### Instructions for Applicants under the *Aggregate Resources Act*

6947 Concession 2, Puslinch, ON  
 Lot 18-20, Concession 1, Township of Puslinch, Wellington County

This letter is being provided by email in accordance with the direction provided in the Objection Form approved by the Ministry of Natural Resources and Forestry (“Ministry”) and in response to the application serving Part 1 on the Township on February 23, 2026. Hard copies will follow by courier. As the comment period has now closed, the Township respectfully requests that the Environmental Registry posting be updated to include the

Figure 1

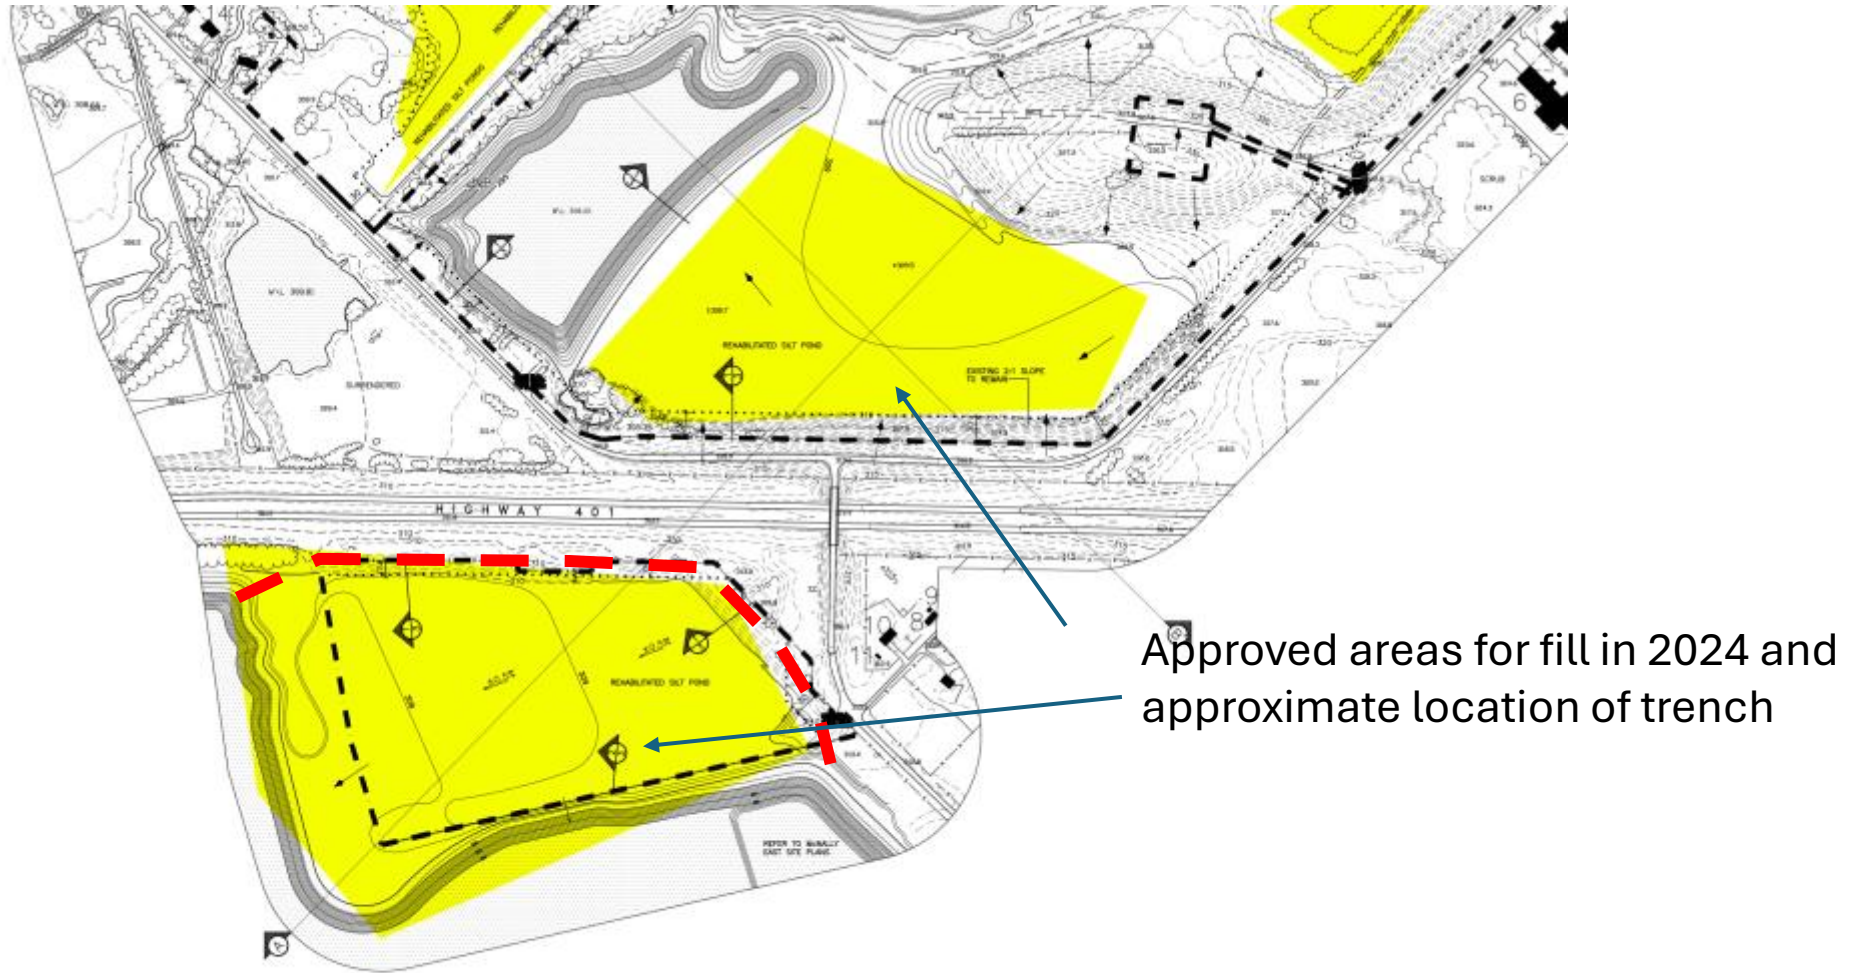
*The proposed pit is surrounded by private property as shown on Figure 1. It is clear throughout the reporting that there will be impacts on both groundwater movement and groundwater elevations beyond the applicant's property lines. For example, all groundwater movement from the CBM property will cease between the proposed lake and Mill Creek along a 1600 m stretch of Mill Creek as shown in the particle tracking exercise. Groundwater levels beneath properties north and south of the CBM owned lands will decrease (east half of site) and groundwater levels beneath properties south and west of the CBM lands will increase (west half of site). There is also the potential for annual seasonal overland flow from the proposed lake onto private lands. The concerns of the private landowners must be addressed. A significant portion of both Mill Creek and Tributary 3 that could be impacted are on private property. To our knowledge no assessment has been made on these private lands.*

Figure 3

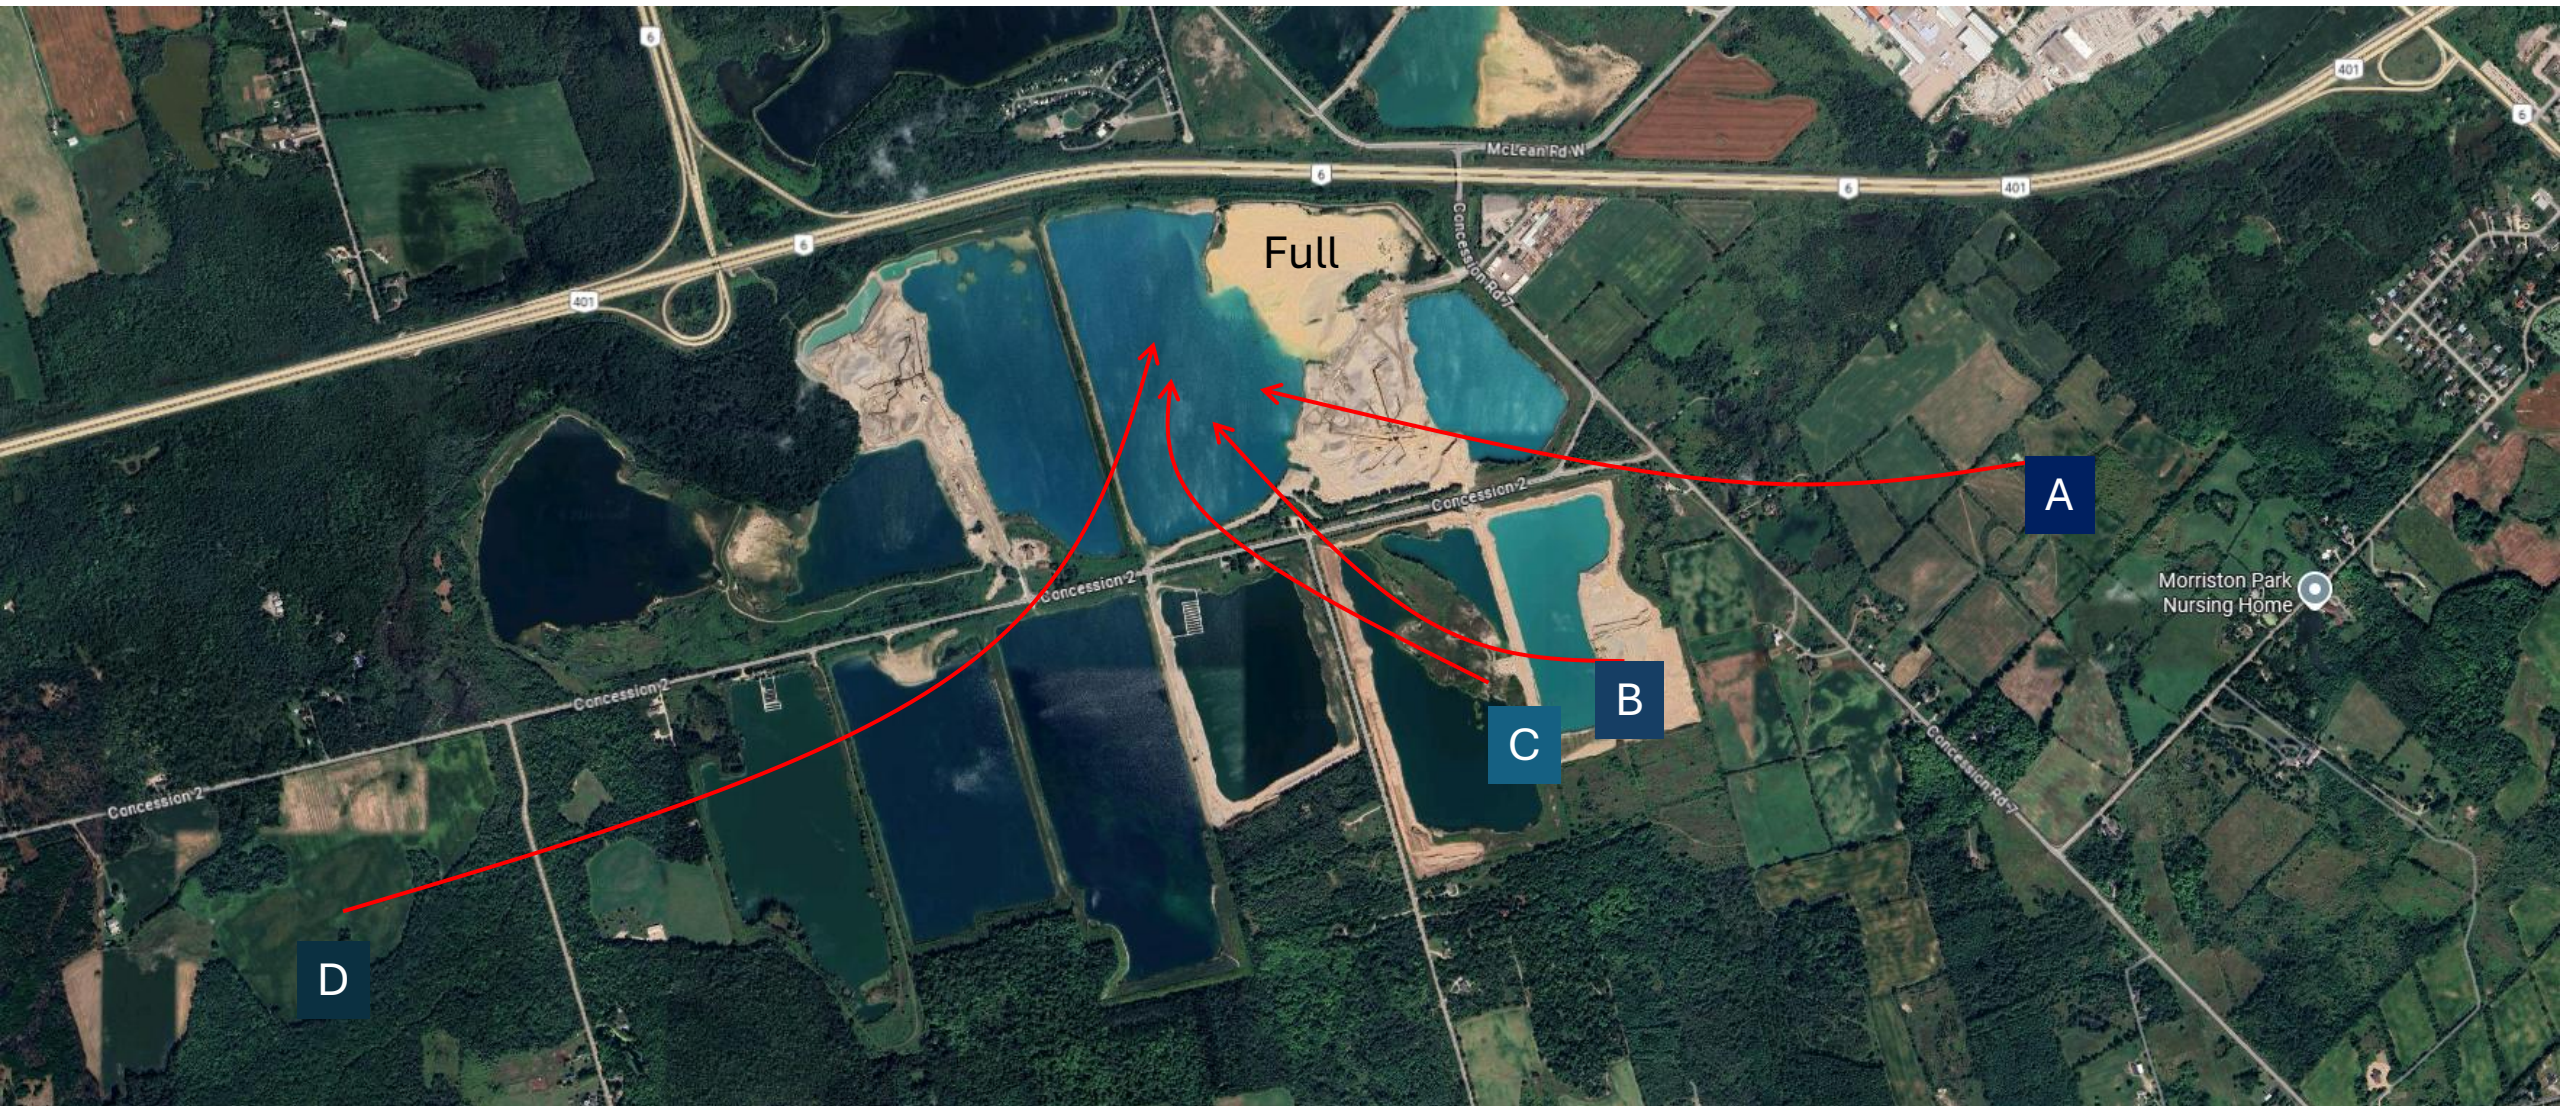
## Potential Effects of Silt Deposition in the McNally Pond on Mill Creek Baseflow

60	This is the first time that Harden was presented with the January 2024 model report. Regarding the Harden Letter of February 11, 2024 the letter clearly refers to Schedule E which shows limited siltation infill in the Aberfoyle South pit area south of Hwy 401. This is the area designated Zone A in the January 2024 WSP report. The image attached shows that Zone A is now completely full of silt and there are four feeder pits proposed to continue to supply silt, designated A through D on the attached figure. The McNally pit will soon be, if not already out of compliance with the agreed to siltation areas from the 2024 OLT. The trench was a suggested mitigation to the noncompliant deposition of silt in Zone A and was not a blanket mitigation for any other infill. The Township expects that amendments to the McNally Pit license will be necessary to allow for continued silt deposition.	Silt at McNally

Table 1

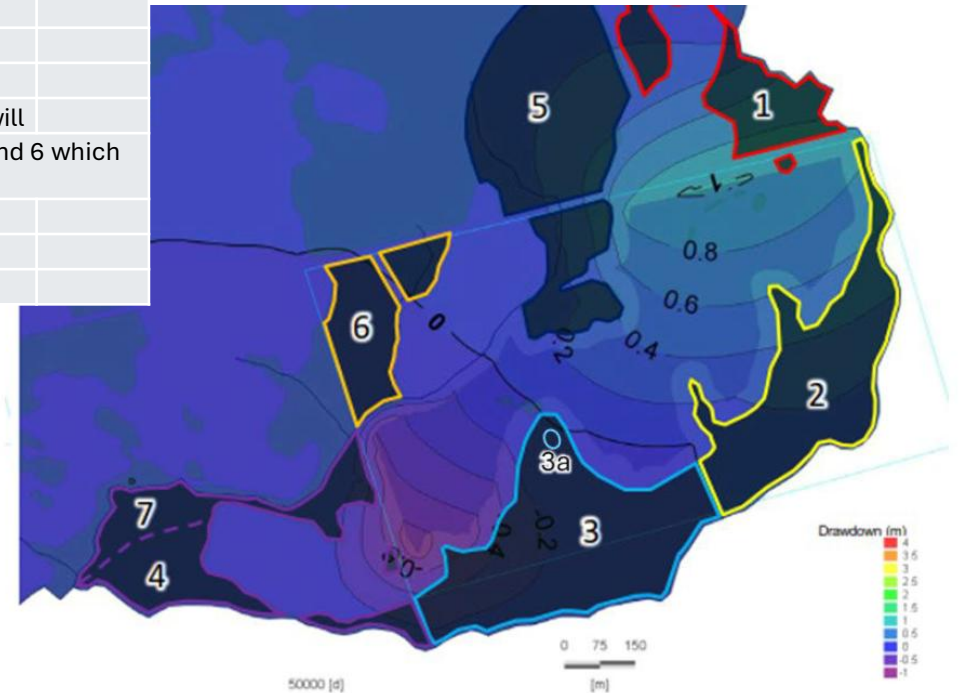
We are relying Aboud and Associates to comment fully on the wetland impacts. We have created Table 1 based on information provided that was provided to us and this summarizes changes in total hydrological support as well as just groundwater support.
